Compliance with EU Battery Regulations

June 2024 (Ver. E: May 2025)

MELSEC MX controllers, MELSEC series programmable controllers, MELIPC series, and GOT2000 series

FA-A-0436-E

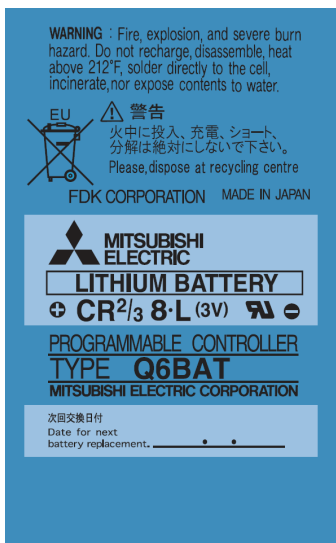
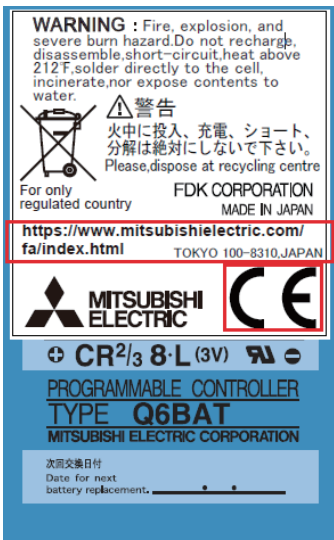
To comply with the EU Battery Regulations, the following indications will be added on the battery label or product packaging depending on the situation.

- CE mark
- Address of our head office
- URL of our website

■ Q6BAT

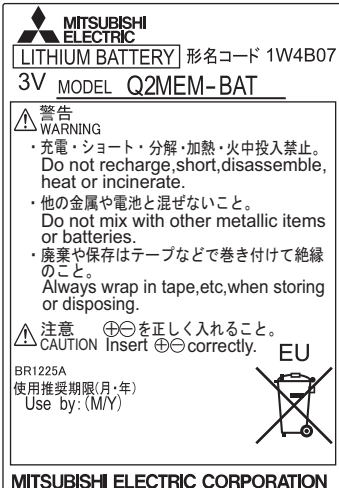
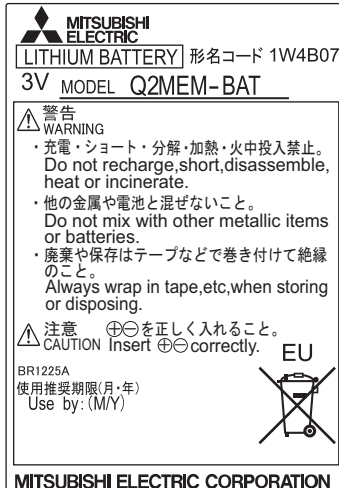
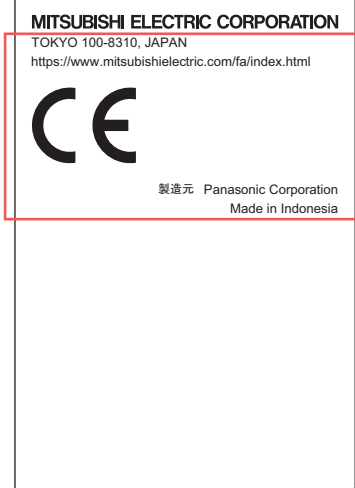
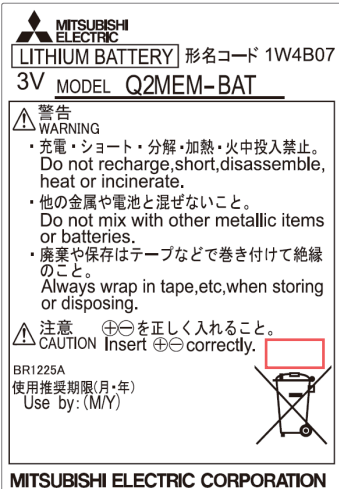
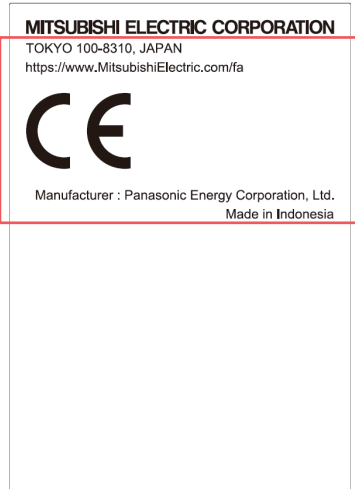
A sticker will be attached, or the label will be changed.

■ Q2MEM-BAT

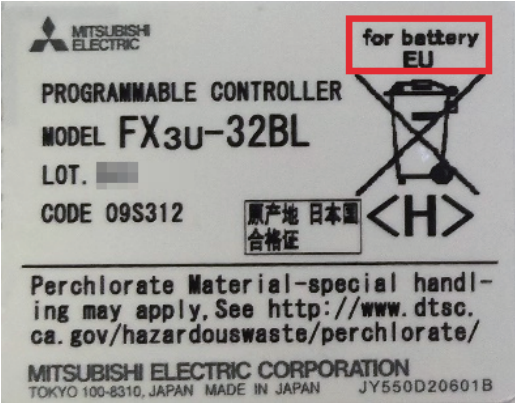
The CE mark, our head office address, and our website URL will be added on the rear of the packaging.
